UNITED KINGDOM HOLOCAUST MEMORIAL & LEARNING CENTRE

Design and Access Statement
January 2026 Addendum

Drawing Title: Proposed Roof Level Option 1A

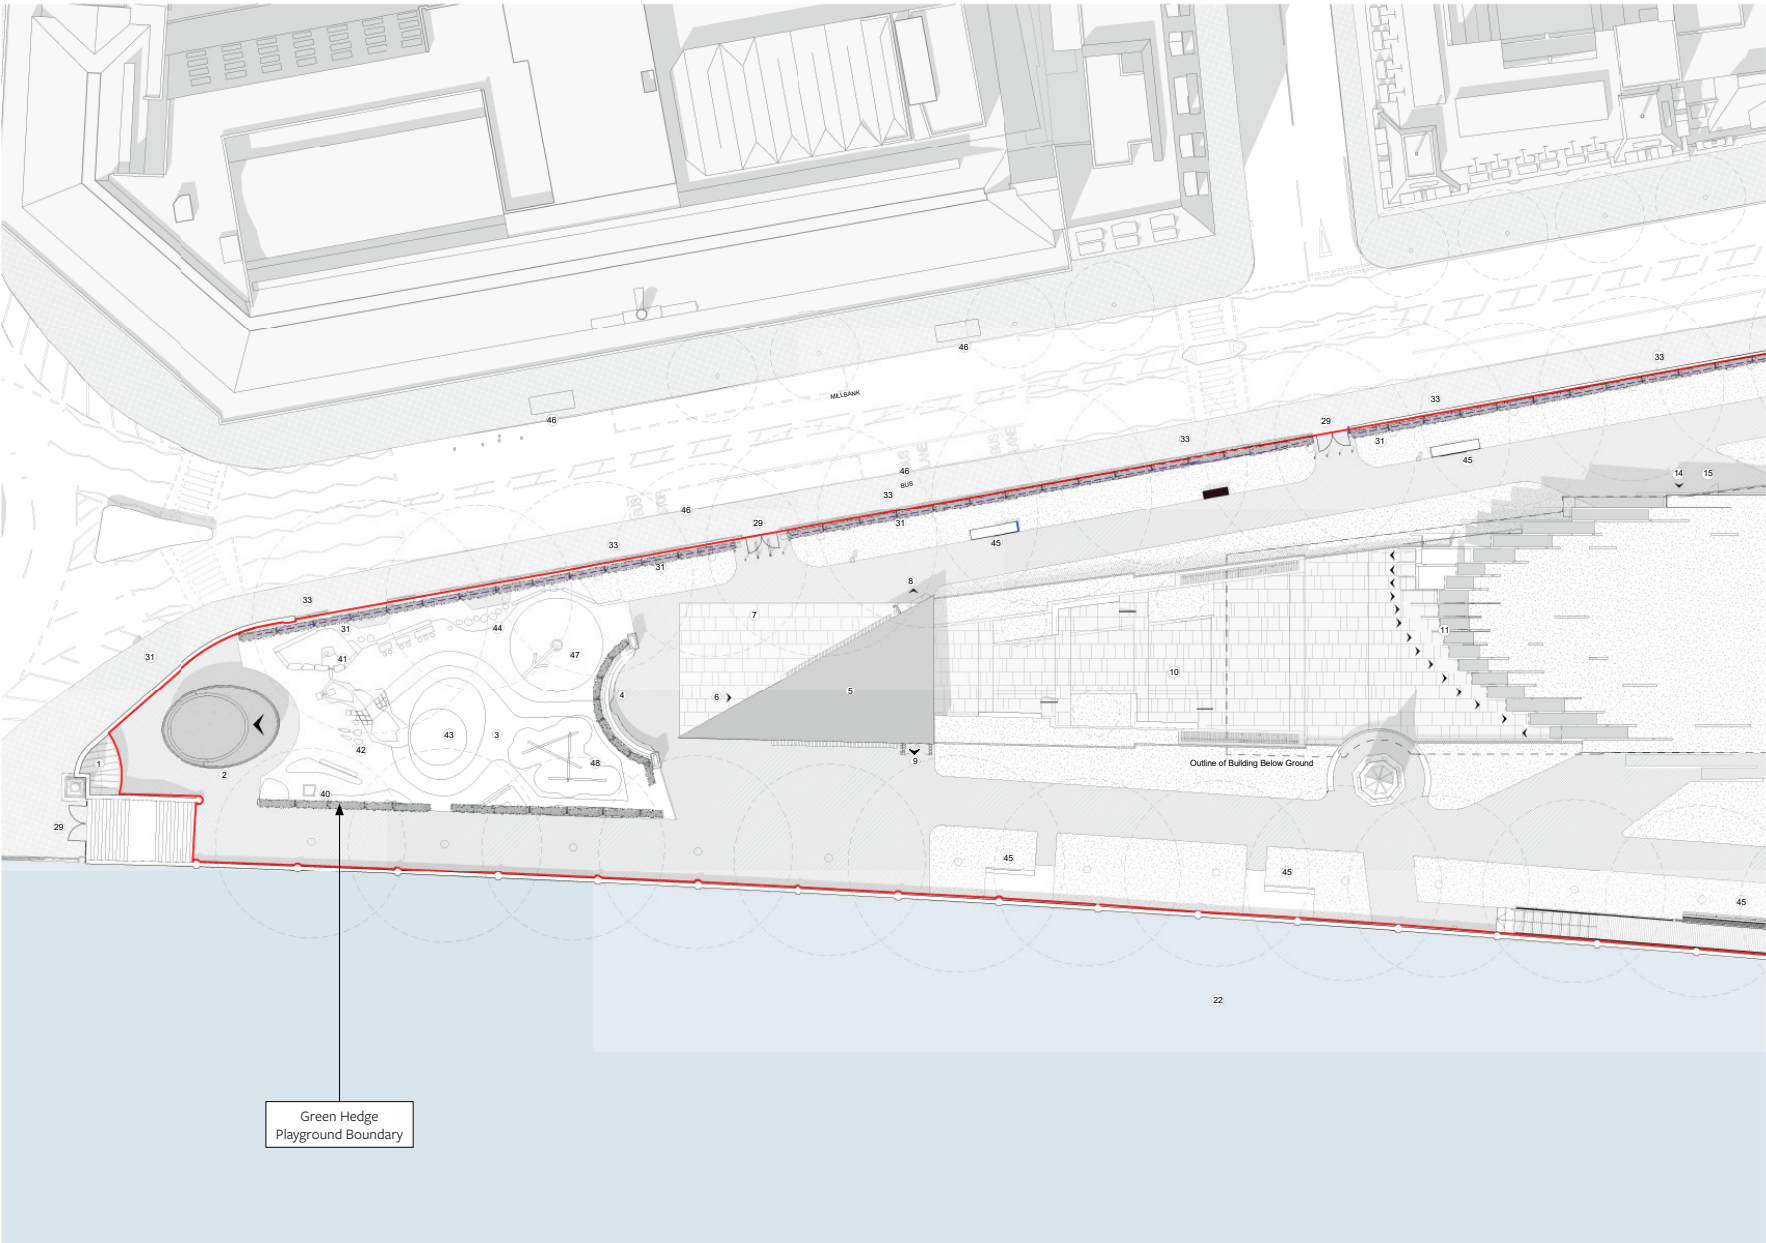
Option 1A - Hedge boundary to the playground

An additional section of hedging would be introduced along the pedestrian Thames walkway, also around the inner line of the Spicer Memorial and the existing railings along Millbank.

Option 1A - HEDGE BOUNDARY TO THE PLAYGROUND
An additional section of hedging would be introduced along the pedestrian Thames walkway, also around the inner line of the Spicer Memorial and the existing railings along Millbank.

Option 1B - Gated entry to the playground with gate from millbank

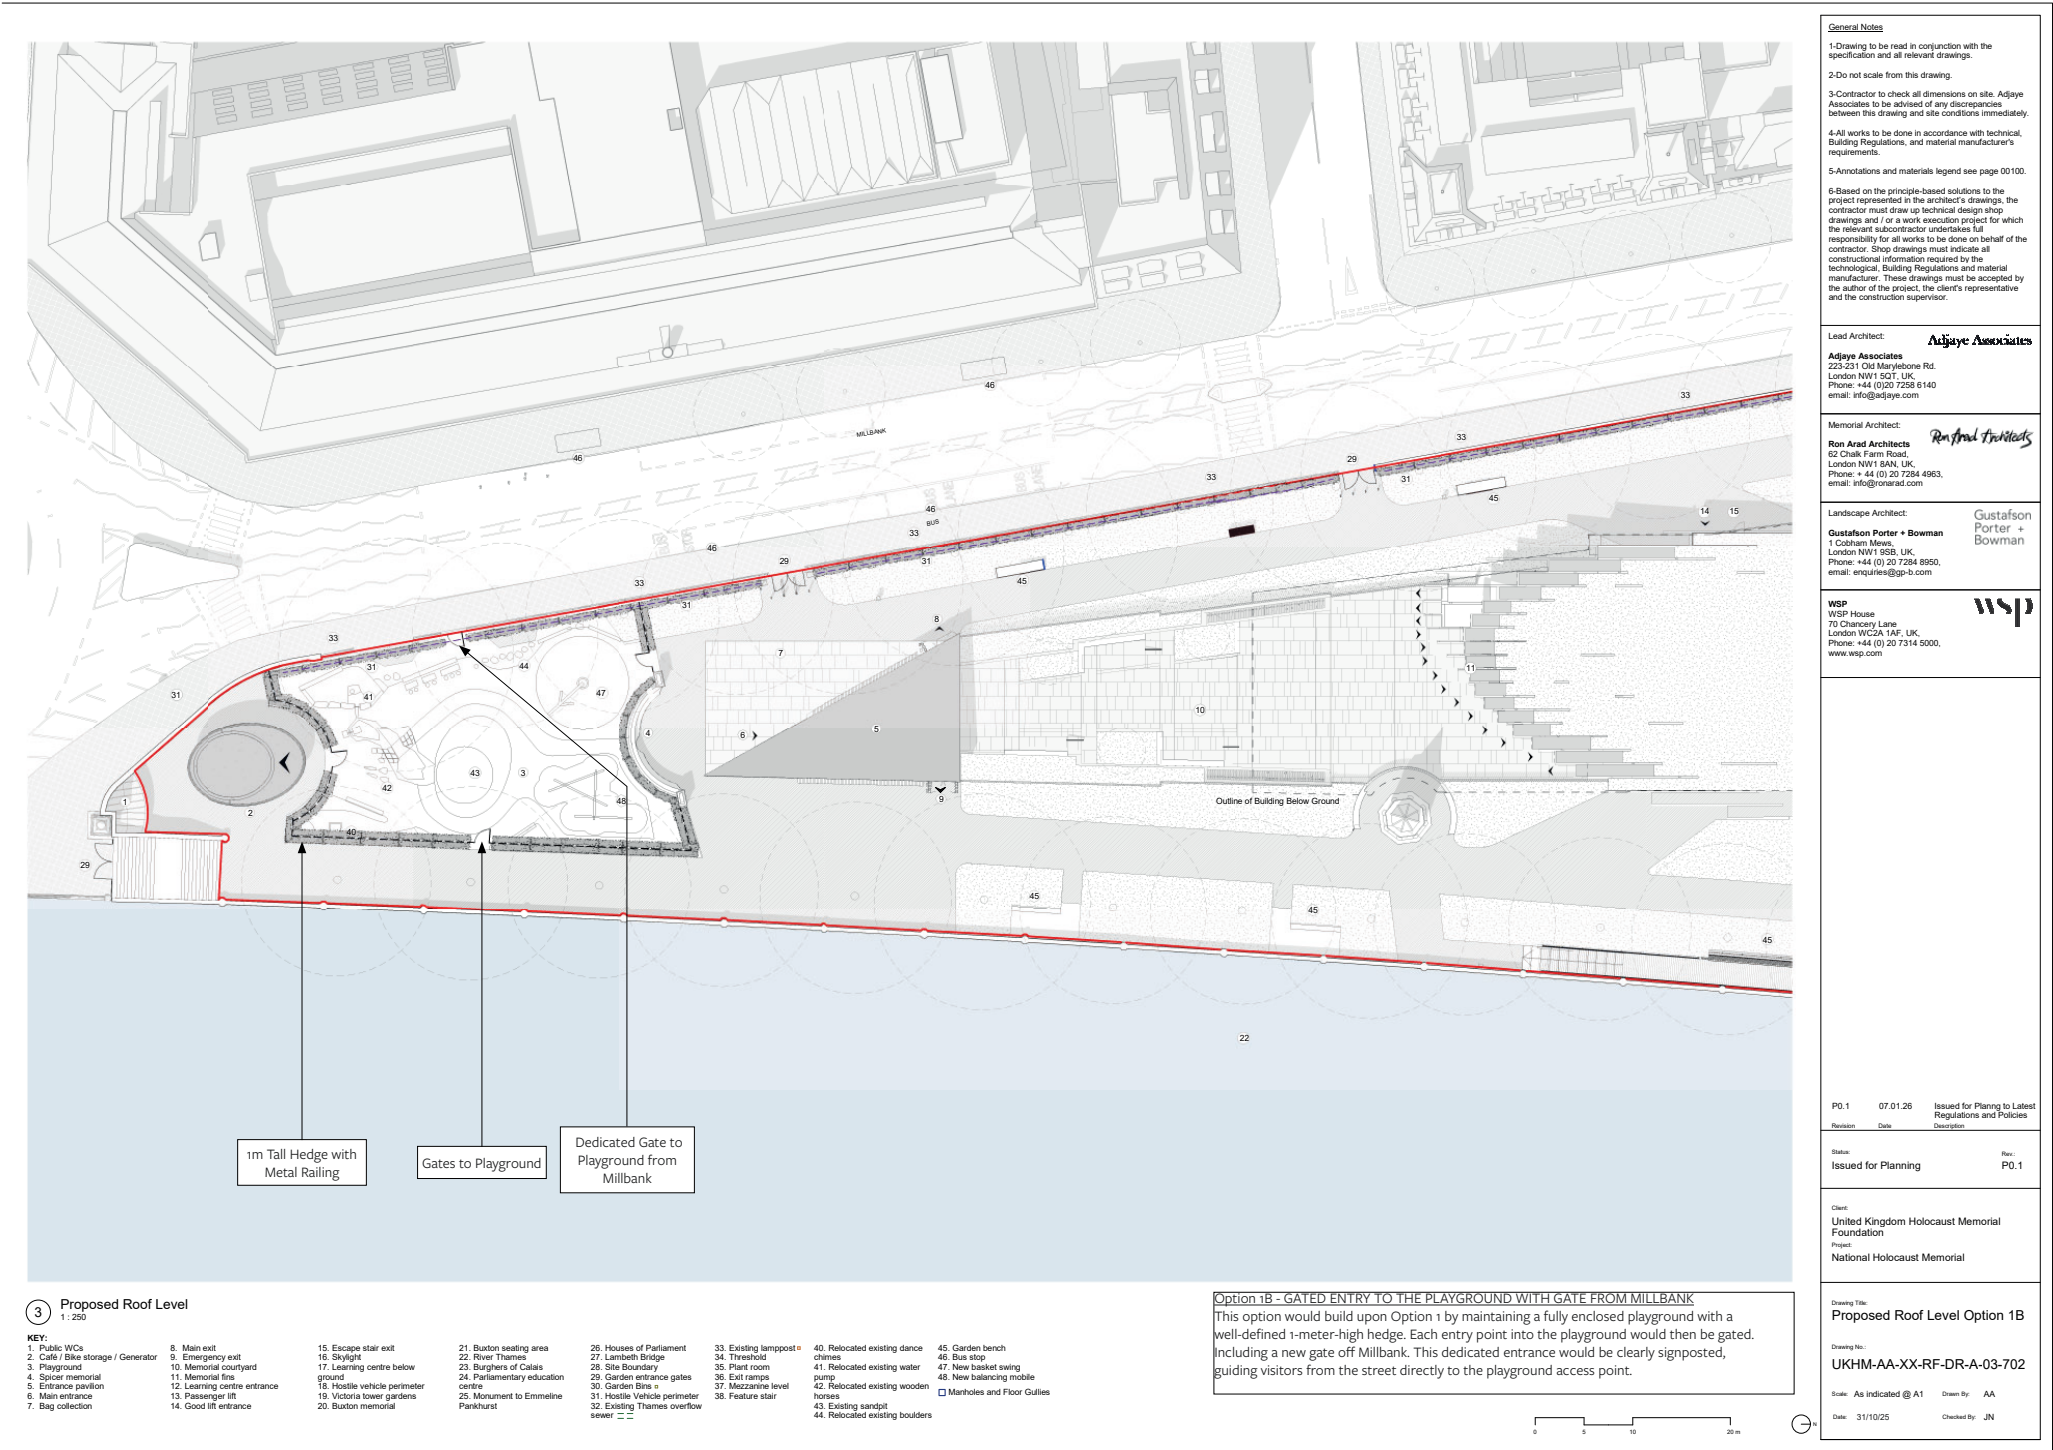
This option would build upon Option 1 by maintaining a fully enclosed playground with a well-defined 1-meter-high hedge. Each entry point into the playground would then be gated. Including a new gate off Millbank. This dedicated entrance would be clearly signposted, guiding visitors from the street directly to the playground access point.

Option 1C - Gated entry to the playground

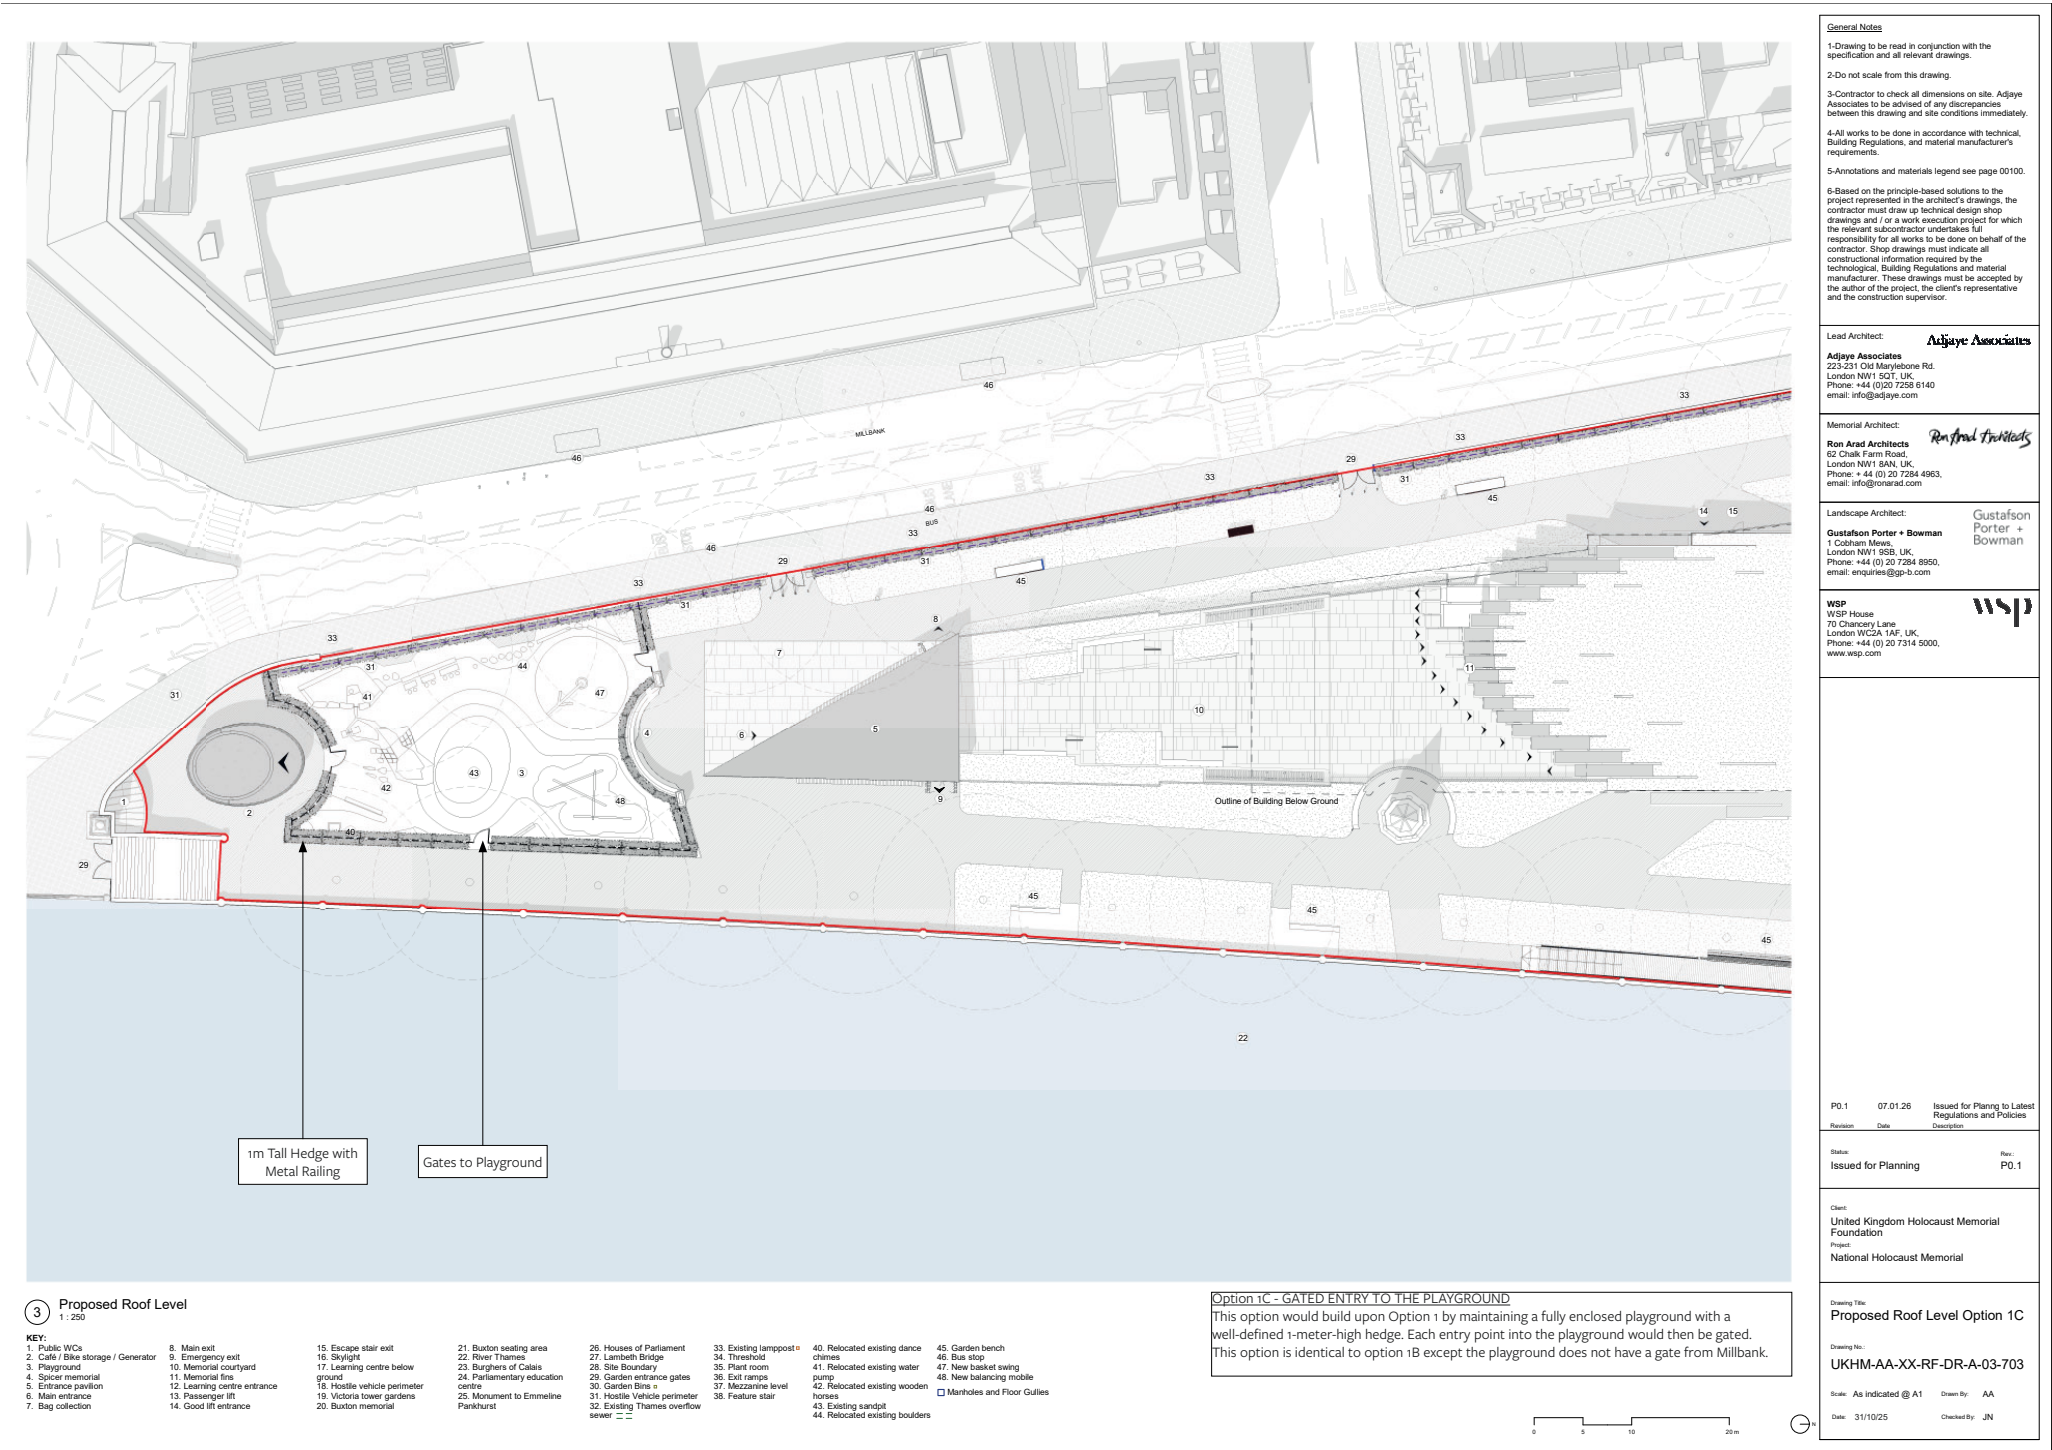
This option would build upon Option 1 by maintaining a fully enclosed playground with a well-defined 1-meter-high hedge. Each entry point into the playground would then be gated. This option is identical to option 1B except the playground does not have a gate from Millbank

Option 1D - Café kiosk removed, back-up generator and cycle parking retained

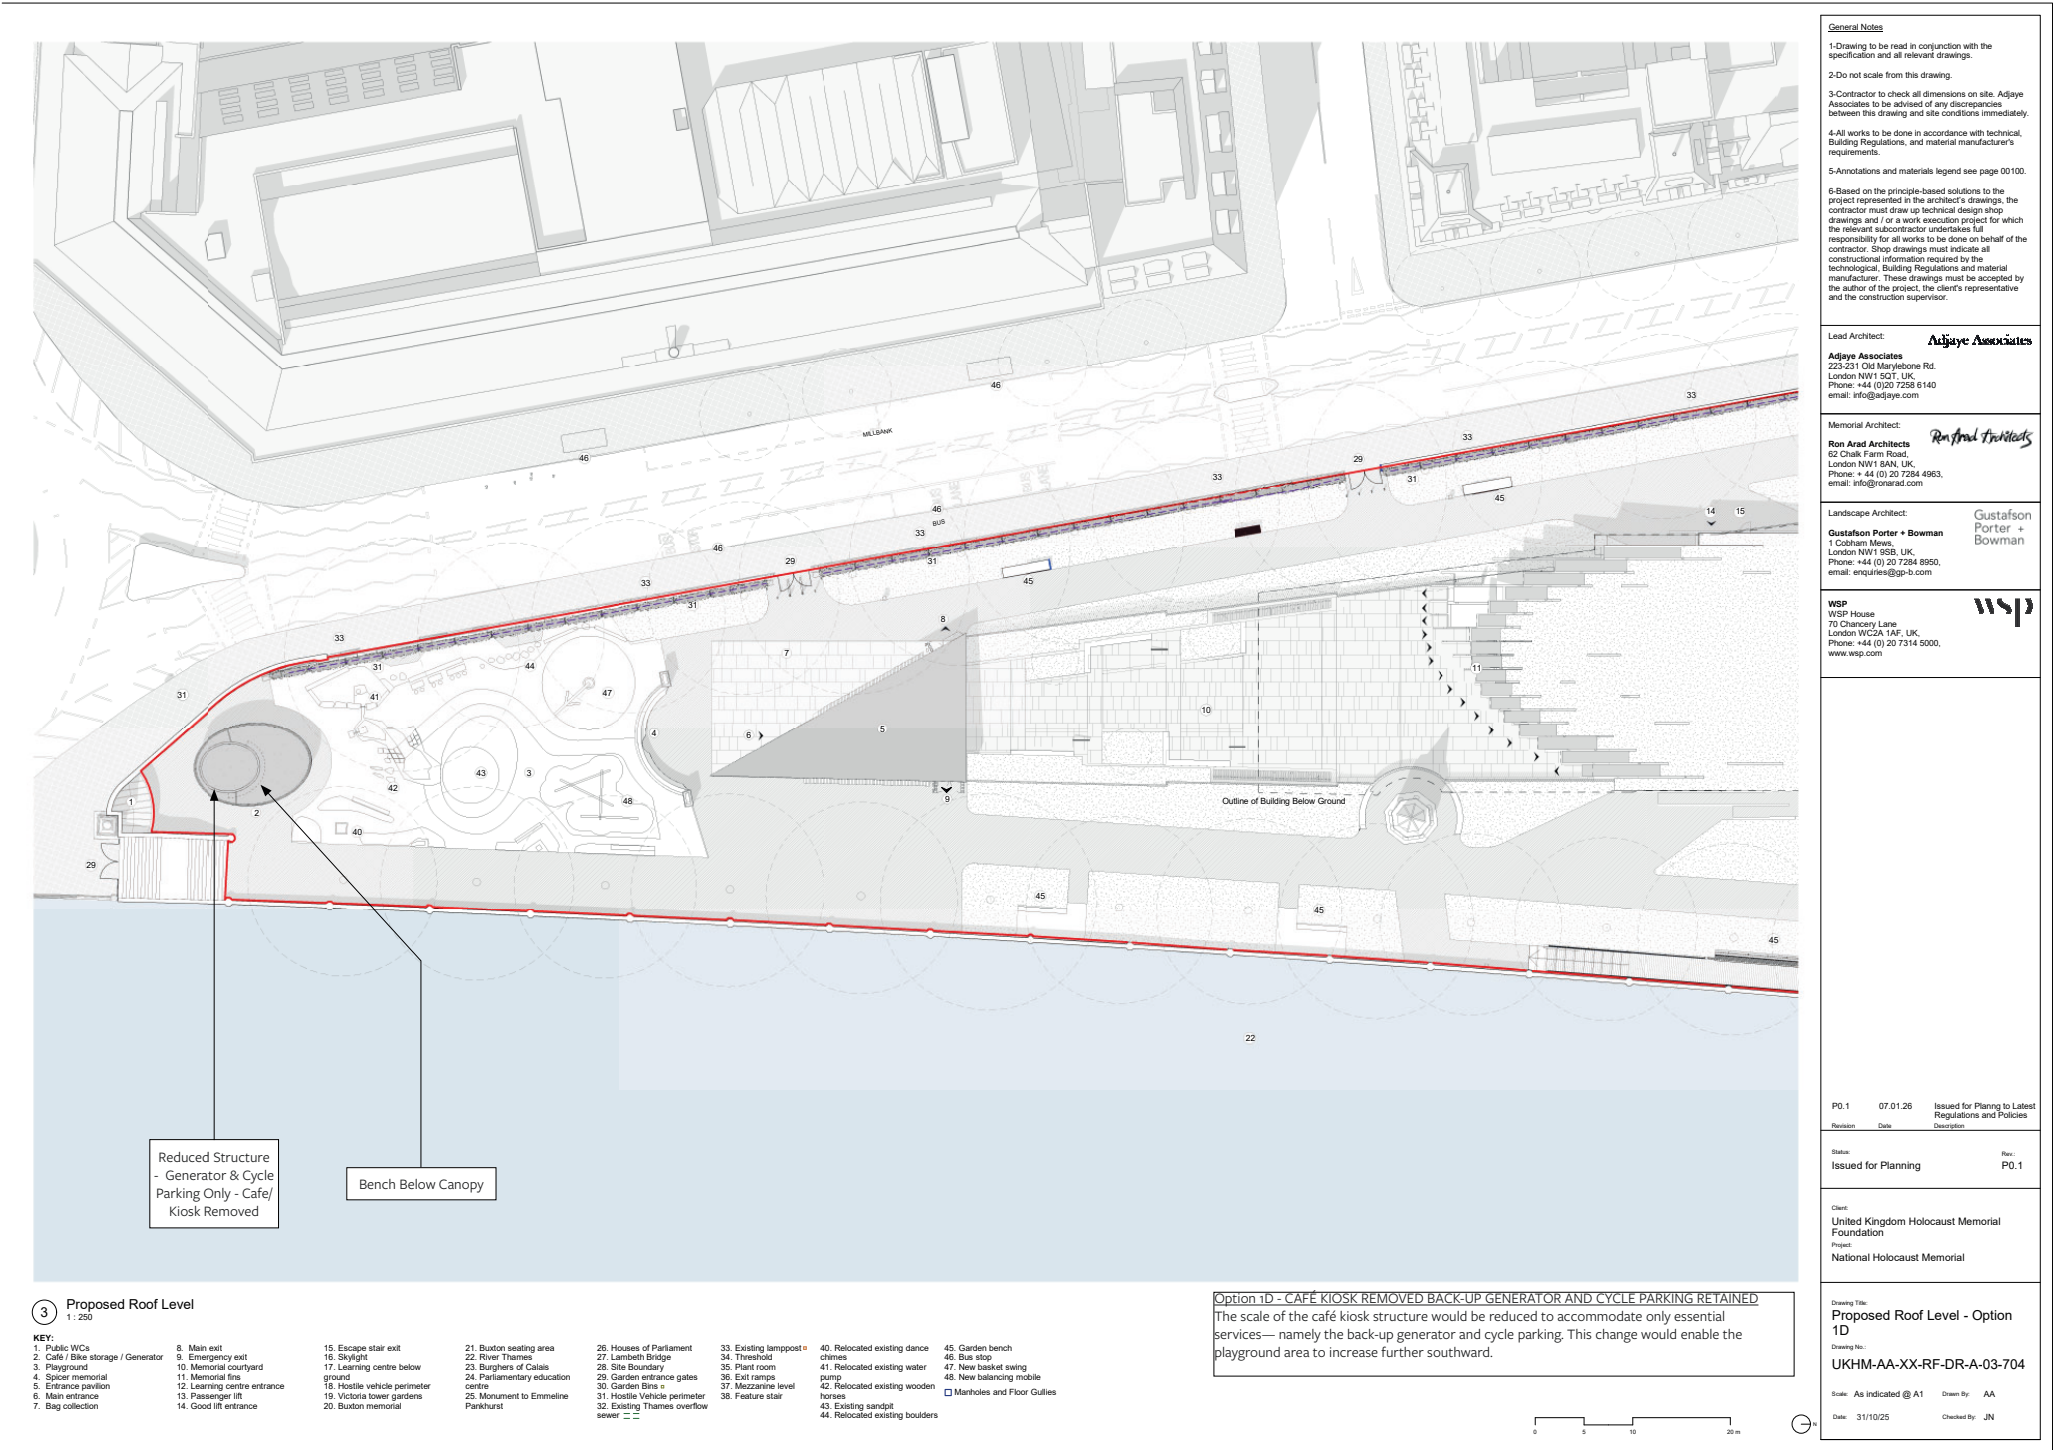
The scale of the café kiosk structure would be reduced to accommodate only essential services— namely the back-up generator and cycle parking. This change would enable the playground area to increase further southward.
